VALUE ENGINEERING REPORT

Spring Street Viaduct Replacement
Over CSX Transportation, Inc.
Project Nos.: BHNLB-9073-00(016) &
BRNLB-9073-00(018)
Fulton County
PI Nos.: 752086 & 752560
January 7, 2009

Georgia Department of Transportation
600 West Peachtree Street
Atlanta, GA 30308
(404.631.1770)

MACTEC Engineering and Consulting, Inc.
3200 Town Point Drive NW, Suite 100
Kennesaw, GA 30144
(770.421.3346)

ITEM N^o: B-1
CLIENT: GDOT
Sheet 2 of 4

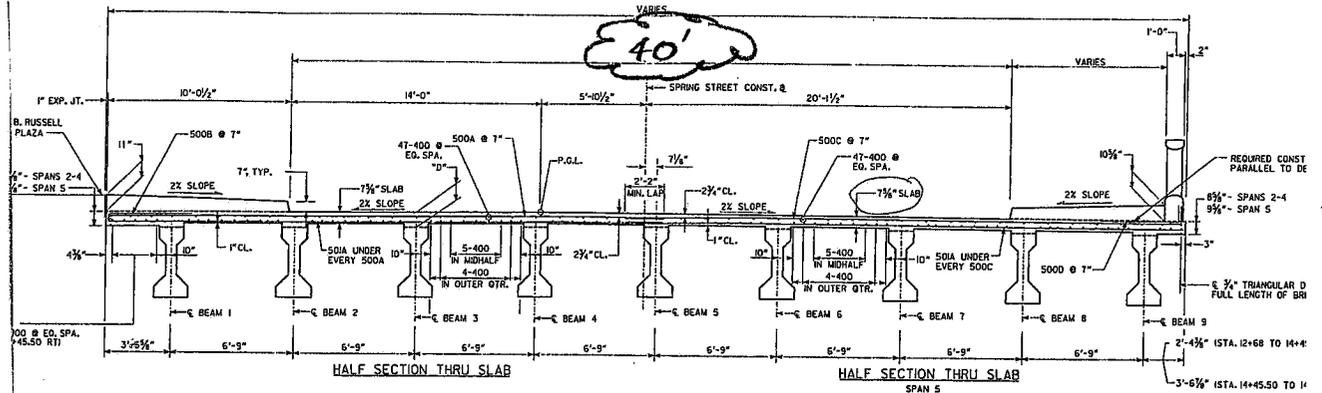
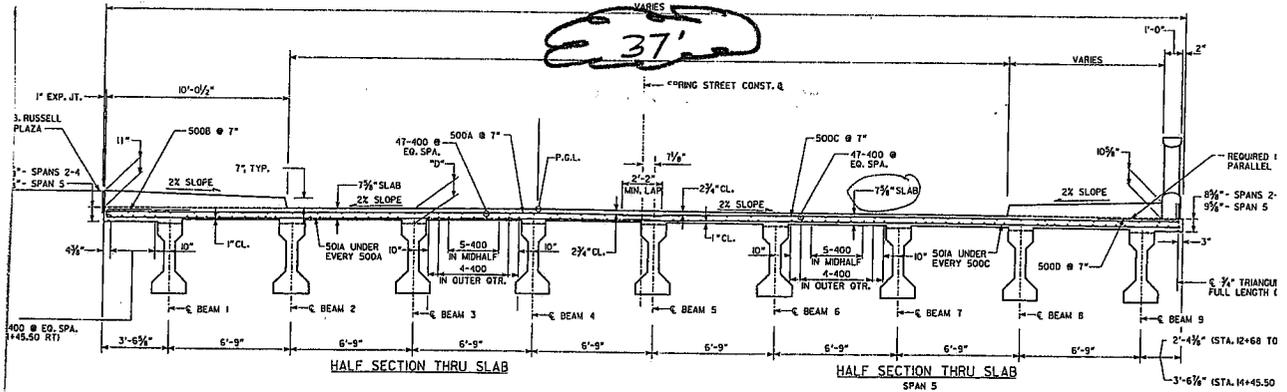
B-1 Use three eleven foot wide travel lanes for Spring Street.

The existing design is for 4-10 foot lanes to match the 1995 constructed segment. This idea proposes re-striping the existing 1995 portion and constructing the new using 3-11 foot lanes. South of MLK Drive Spring Street carries two lanes of traffic in each direction, and North of Marietta Street it carries four ten foot lanes in one direction. The proposed three 11 foot lanes provides a good transition.

STA 20+38.78 TO 27+77.87 = 739.09 feet X 62.92 feet = 46,503.54 SF
\$/SF = \$11,323,152 / 46,504 = \$243.49 / SF

A 3 - foot reduction in bridge width = 3 ft. X 2,217.27 SF X \$243.49 = \$539,883

A 3- foot reduction in width = 3 ft X 288.5 ft. = 865.5 SF X \$169.65 = \$146,832

ITEM N^o: B-2
CLIENT: GDOT
Sheet 2 of 4

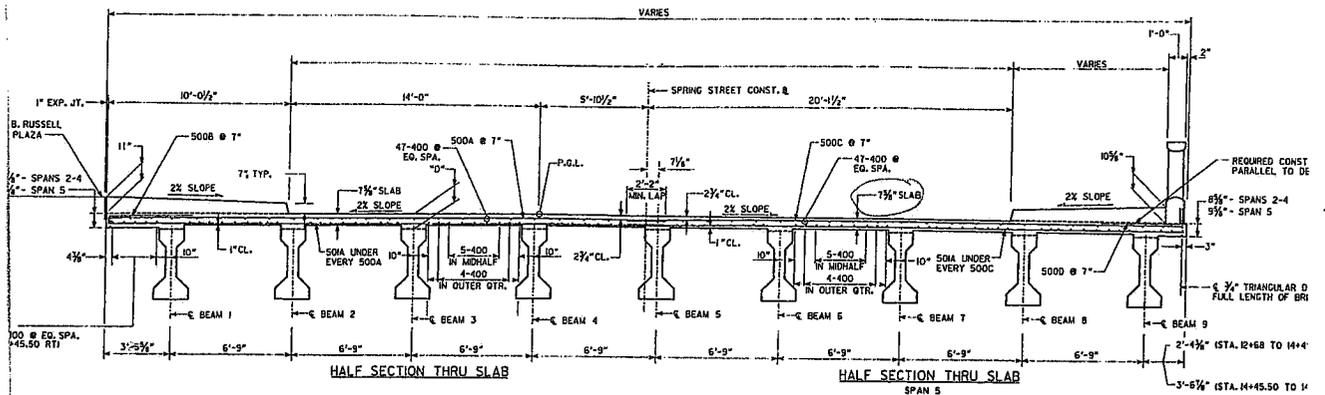
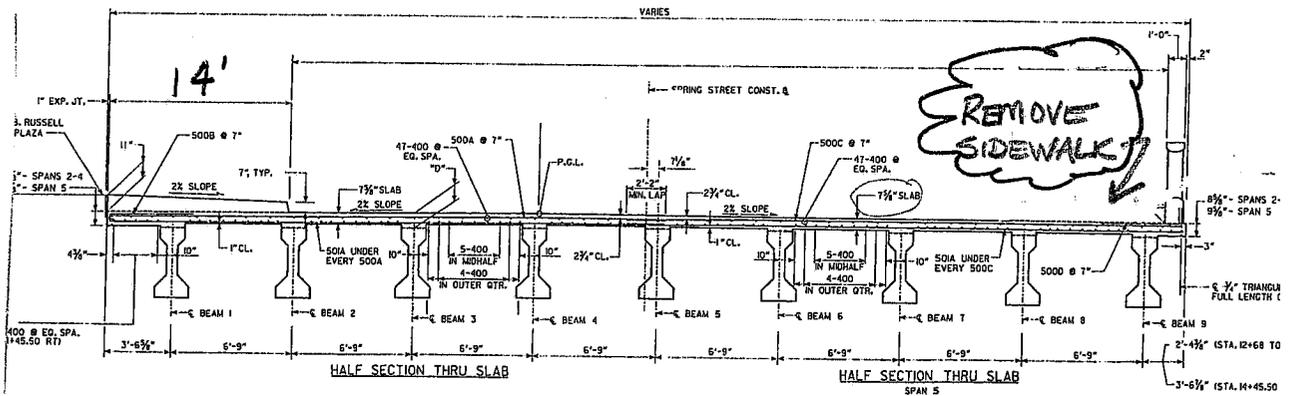
Use 1 – 14' sidewalk on the west side of Spring Street north of the section built in 1995, instead of the original design of 2 – 10' sidewalks.

The existing design uses 2 – 10' sidewalks on each side of Spring Street (see Note). The north end of Spring Street has no development adjacent to the east side of the road. Pedestrian traffic could shift to the west side of Spring Street in this area since there is no development and no need to draw pedestrians to the east side of Spring Street. The sidewalk is part of the bridge deck, and therefore a reduction in the sidewalk width would result in an overall reduction in the bridge structure.

Savings = 6 ft. X 739.09 ft. = 4,434.54 SF X \$243.49 = \$1,079,766 + markups

ITEM N^o: **B-5**
CLIENT: GDOT
Sheet 2 of 4

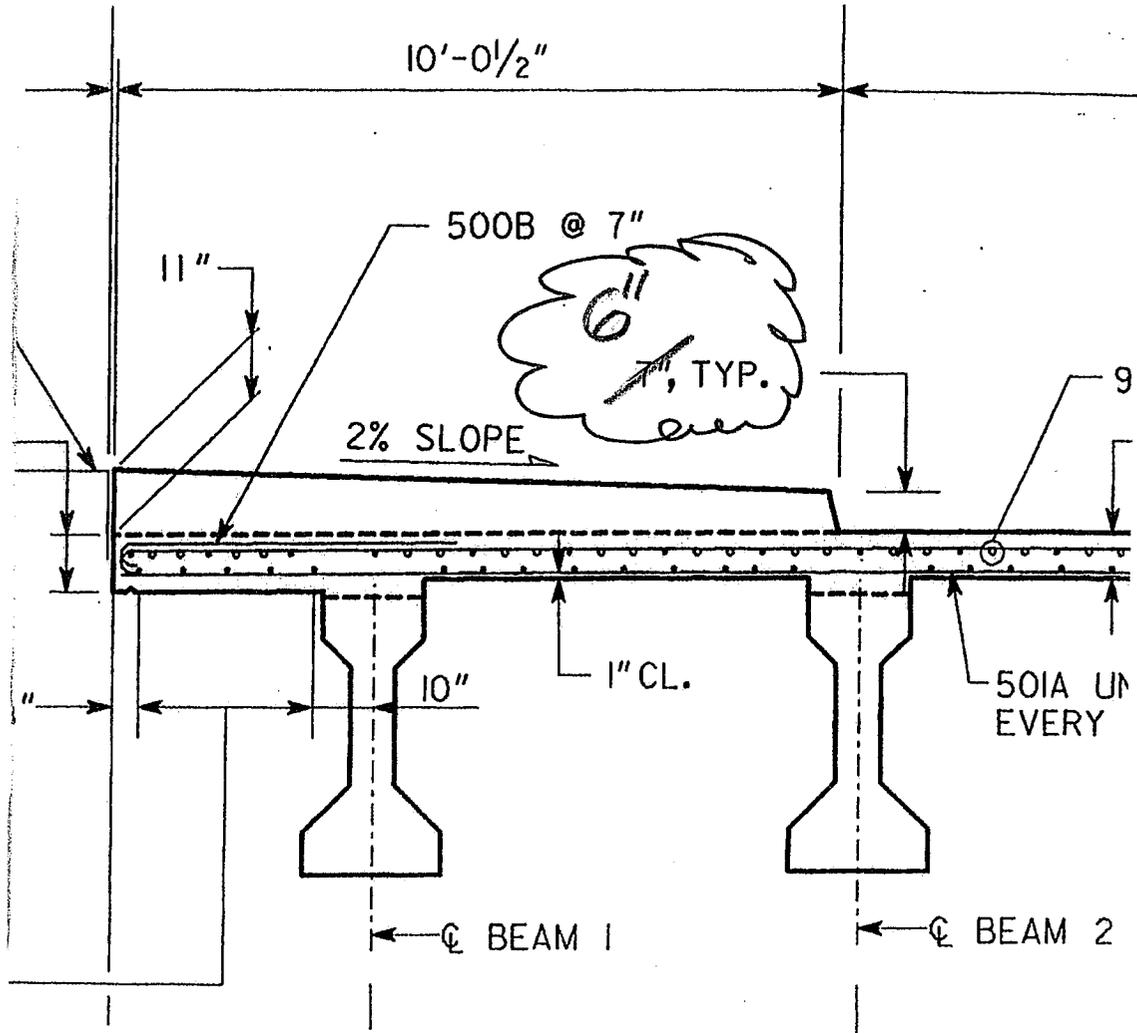
Use six inch thick sidewalks on the bridges.

The current design provides for seven (7) inch thick sidewalks to match the existing area constructed earlier in 1995. The current GDOT standard is 6 inches thick. A one inch thick difference in the sidewalk is not noticeable. We do not see any constructive reason to provide a thicker sidewalk to match a previously constructed segment, when it does not conform to current criteria. The benefits include less material, dead weight, and lower costs. Most importantly, it conforms to the GDOT standard.

$$2 \times (958 \text{ ft} \times 10 \text{ ft wide} \times 1/12 \text{ ft thick}) \times (1 \text{ cy} / 27 \text{ cf}) = 59.14 \text{ cy}$$

ITEM N^o: B-6
 CLIENT: GDOT
 Sheet 2 of 4

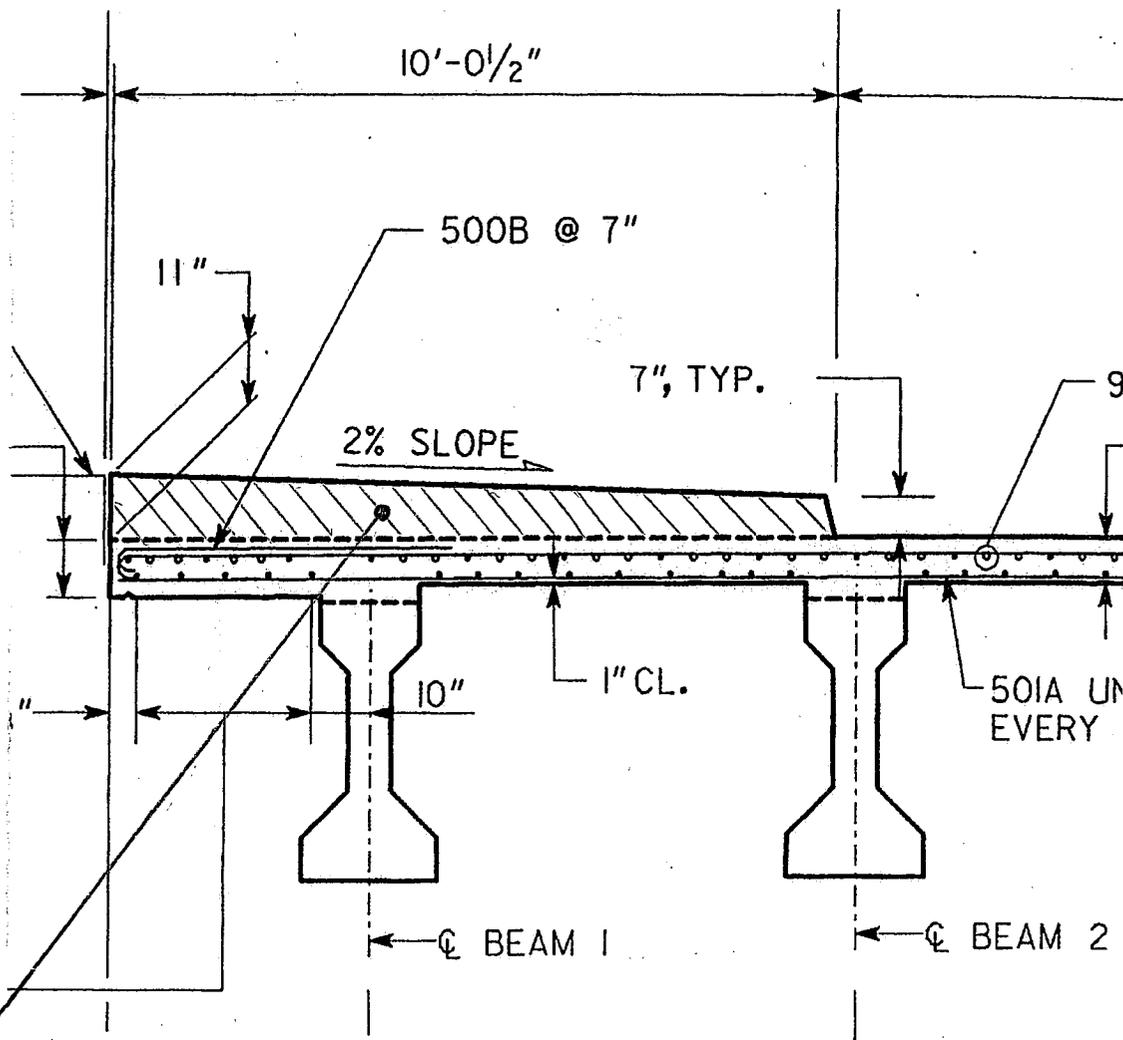
Use a lower grade of concrete for the sidewalk on the bridge; Class B.

The current design uses high grade, Class AA concrete at \$1,250 per cy for the bridge deck, including the concrete sidewalk. Since the concrete sidewalk rests on the new, sound bridge deck, there is no additional structural capacity required or provided by the sidewalk. The purpose is to delineate the roadway, provide a gutter line and support pedestrian traffic on the bridge. A lower grade of concrete can be used. This will reduce the project construction cost while providing the same project function.

$$10 \text{ ft} \left(\frac{11 + 7}{2} \right) \times \frac{1 \text{ ft}}{12 \text{ in}} = 7.5 \text{ ft}^2$$

ITEM N^o: **F-1**
CLIENT: GDOT
Sheet 2 of 4

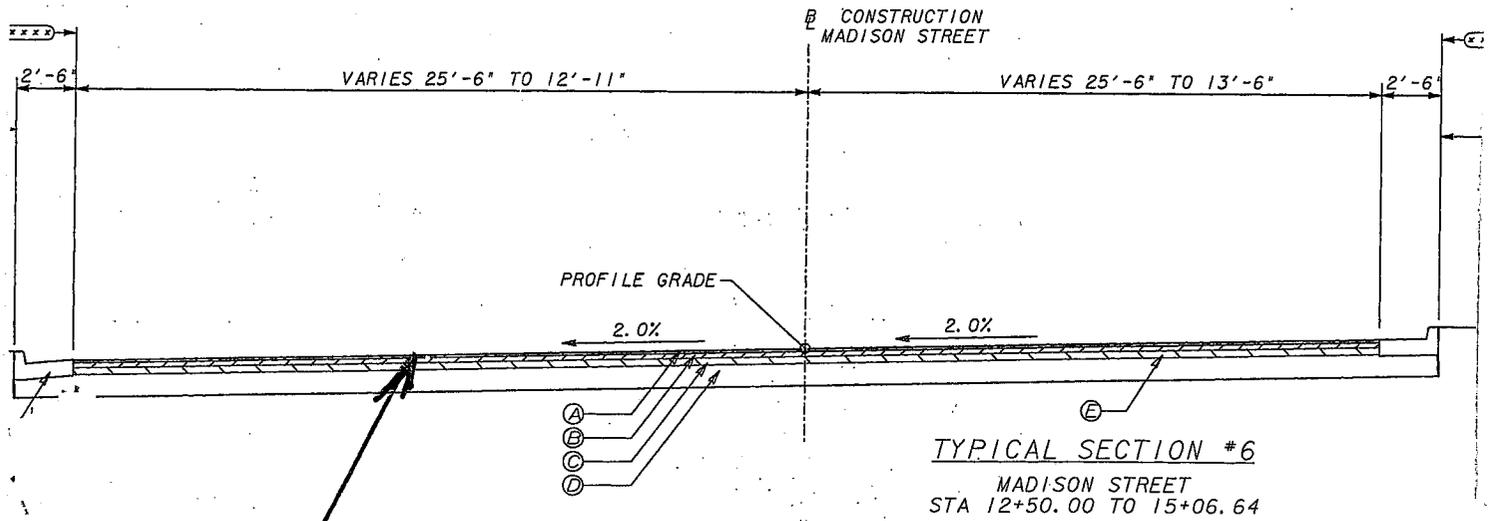
Rather than total reconstruction and improvements, provide only a resurfacing and other minor improvements.

This area is a dead end area accessing the loading dock of the post office building and other maintenance / utility vaults in the area of the south abutment. This area will be disturbed during construction of the Spring Street overpass however it will never be further developed. Basically, it will be an access drive for the building and the utilities. There is no need to provide for full depth pavement with concrete curb and gutter. A 2 inch resurfacing / restoration with minor signage and improvements upon completion of the structural construction will be sufficient for this area. This will provide some cost savings for the project.

USE 2" OVERLAY

$$(5400 \text{ sf} \times 2 / 12 \text{ ft}) (150 \text{ \#/cf}) (1 \text{ ton} / 2000\#) = 68 \text{ tons}$$

PLAN AND ELEVATION
 SPRING STREET VIADUCT OVER
 CSX TRANSPORTATION
 BRNLB-9073-001016
 BRNLB-9073-001018
 FULLTON COUNTY
 SCALE: 1" = 20'-0"
 NOVEMBER 2007

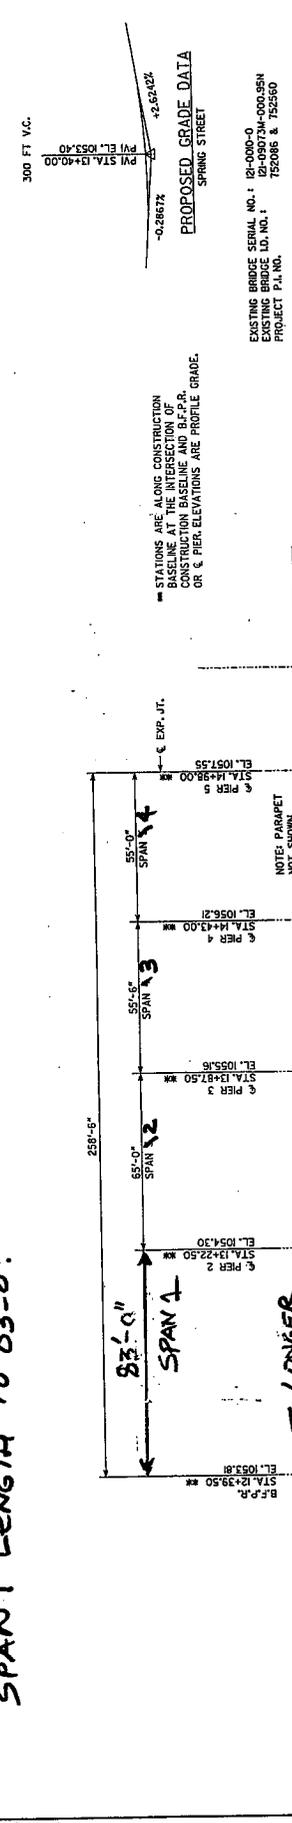
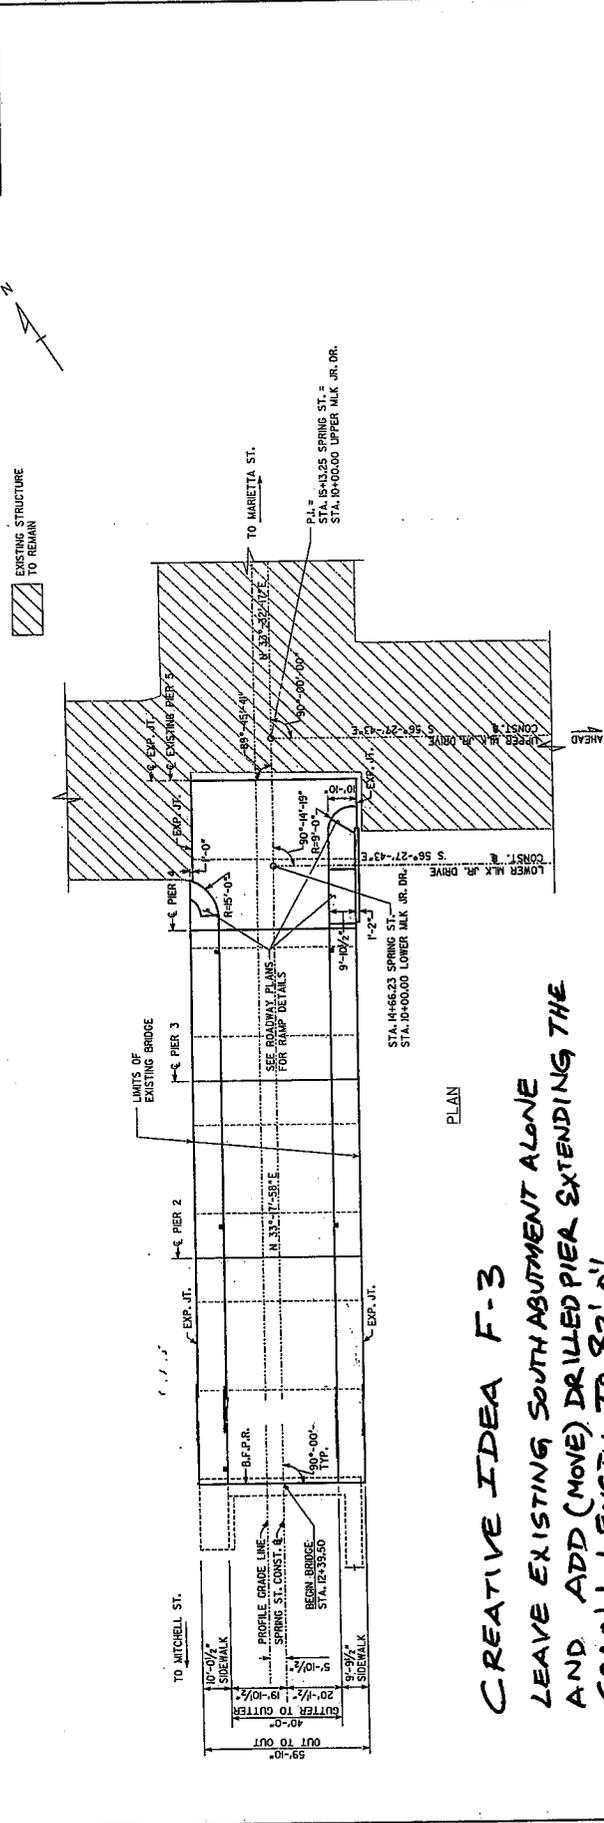
Leave the existing Abutment alone and add a new drilled caisson in front of it to support the superstructure for the new bridge

The existing South Abutment is a 90 year old structure and carries several utilities. A new substructure (drilled caisson) is needed to prevent possible future failure due to age of facility.

CREATIVE IDEA F-3
 LEAVE EXISTING SOUTH ABUTMENT ALONE
 AND ADD (MOVE) DRILLED PIER EXTENDING THE
 SPAN 1 LENGTH TO 83'-0"

LONGER BEAM
 ELIMINATE SUBSTR.
 NEW DRILLED CAISSON
 IN FRONT
 OF EXIST.
 SOUTH ABUTMENT

ITEM N^o: **F-5**
CLIENT: GDOT
Sheet 2 of 8

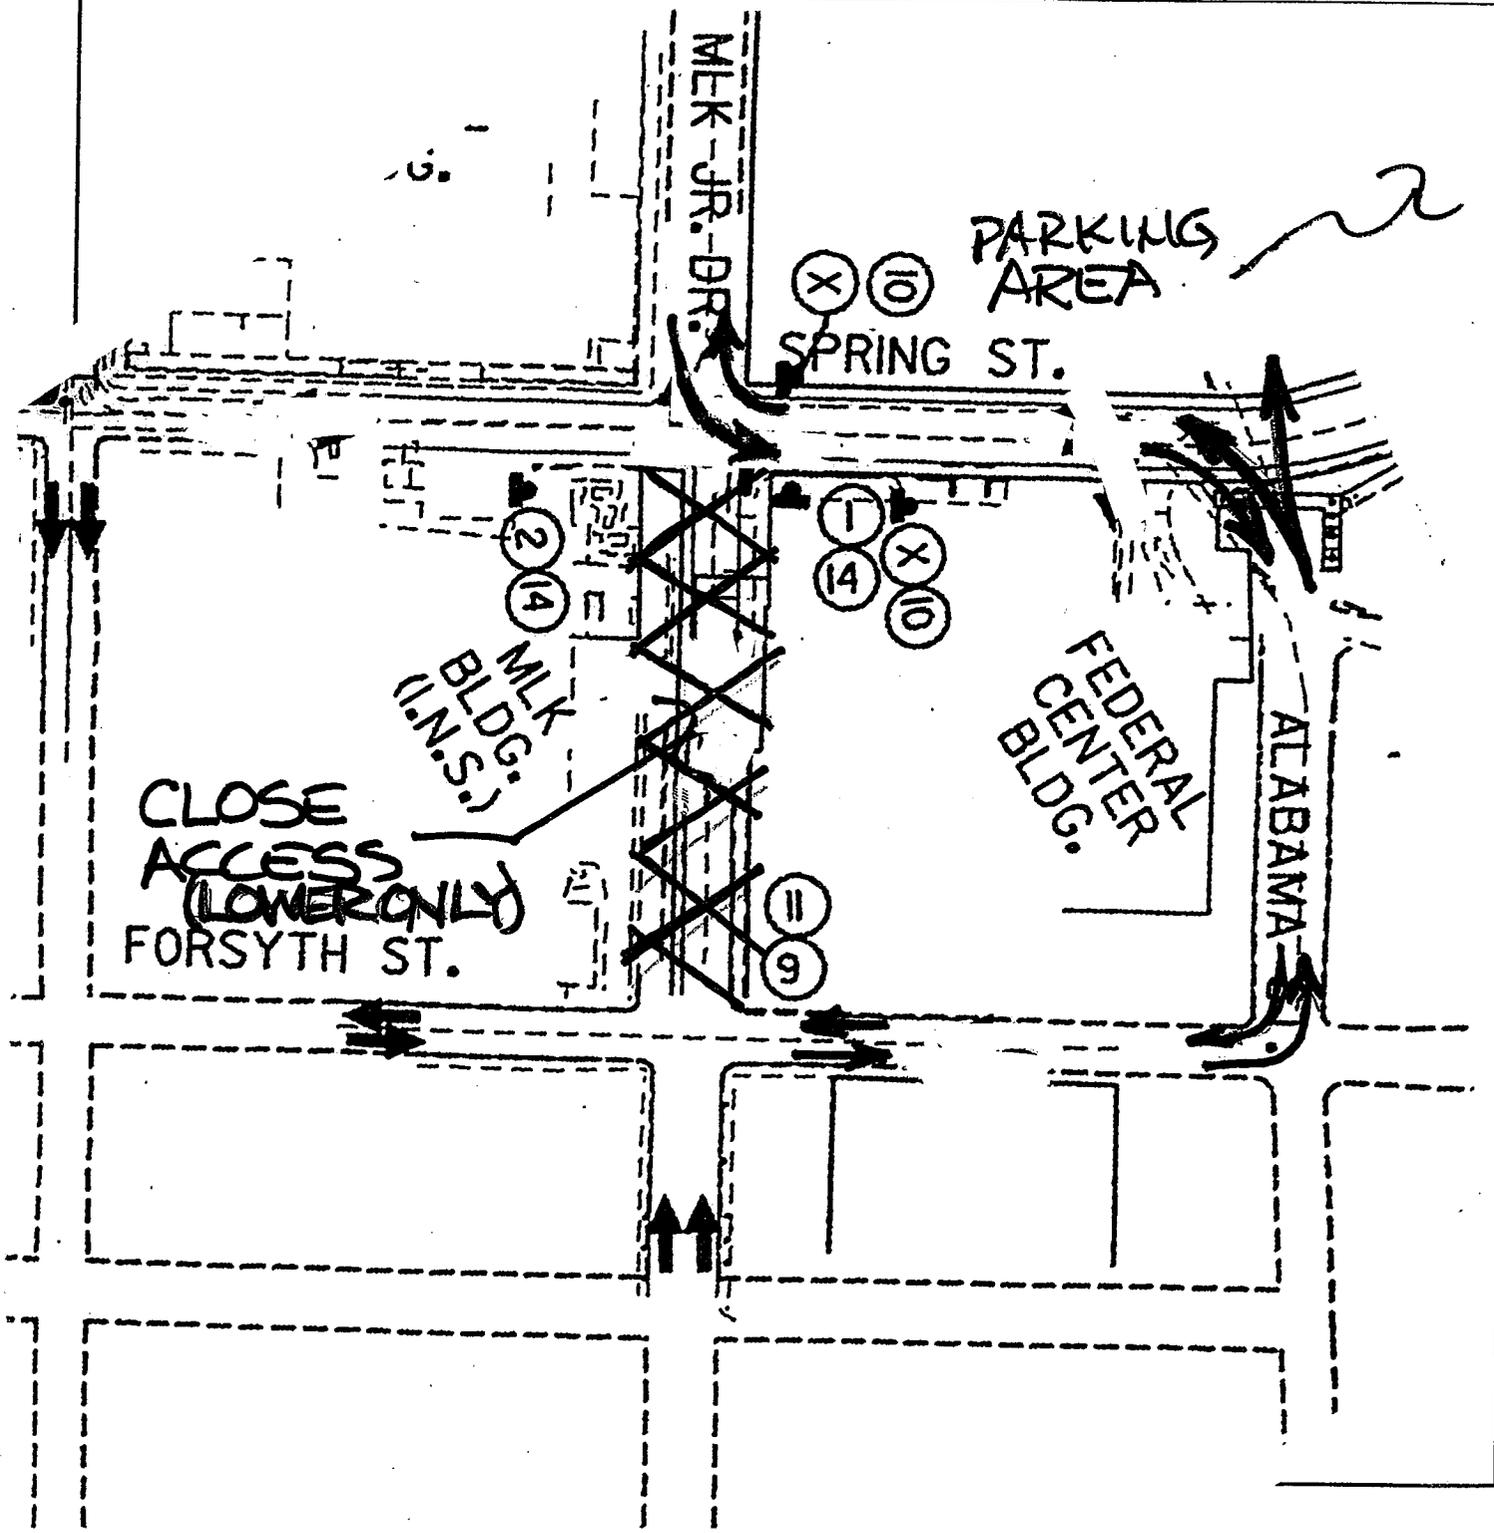
Eliminate this access. Use current side road, Alabama Street.

Based on the traffic information included in the plans, 95% of the traffic using lower MLK turn right and access the parking lot, which is also conveniently accessed via Alabama Street. It therefore does not appear lower MLK service is required.

Additionally, the volumes of traffic are relatively low. Alabama Street has the capacity to handle the additional traffic load. The project benefit will be reduced construction costs while allowing similar traffic movements. Another benefit would be eliminating an awkwardly oriented intersection.
